RFP# 8525 Cosumnes River Blvd Rectifier Replacement Project Q&A's Revision No.3

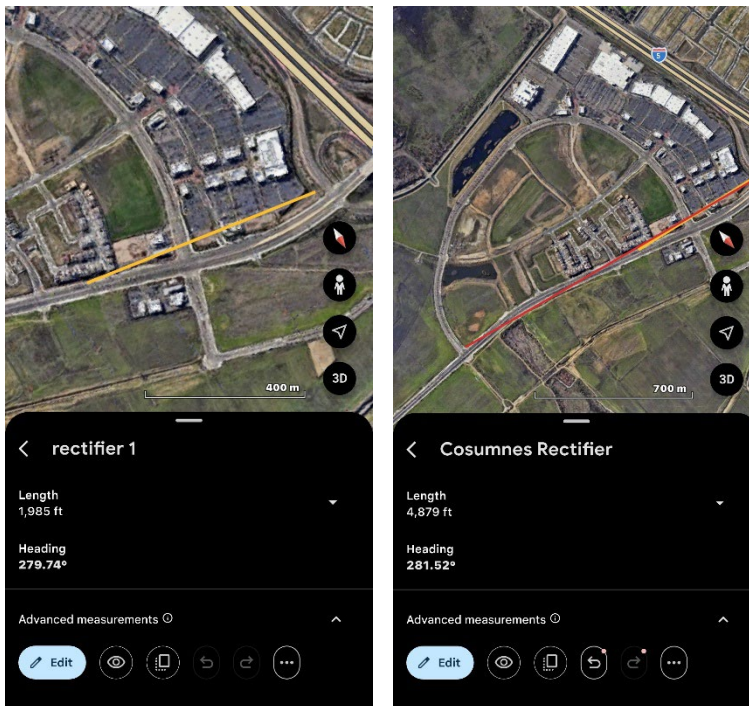
1. Upon further review, we have determined that the SMUD meter number provided does not appear to be correct, as the indicated distance does not align with the rectifier location. Please see the attached images for reference. The Cosumnes rectifier is located approximately 5,000 feet east of Beach Lake Road and Interstate 5. The meter number provided appears to correspond to a different rectifier further down the roadway, located approximately 2,000 feet east of Beach Lake Road and Interstate 5. Also, we reached out to SMUD to get information on the meter number that was given and they couldn't even see that which is why we started looking deeper.

*Thank you for raising this and for checking with SMUD. The RFP states that the Contractor is responsible for coordinating with SMUD for electrical service to the new rectifier. After further internal review, we were not able to verify the meter number previously referenced, and we believe SMUD has deactivated the account that once served this location. Accordingly, the selected Contractor will need to work with SMUD to establish a new electrical service and meter for the Cosumnes River Blvd Rectifier site. This clarification is consistent with the utility-coordination responsibilities already described in the RFP and does not change the scope or evaluation criteria.*
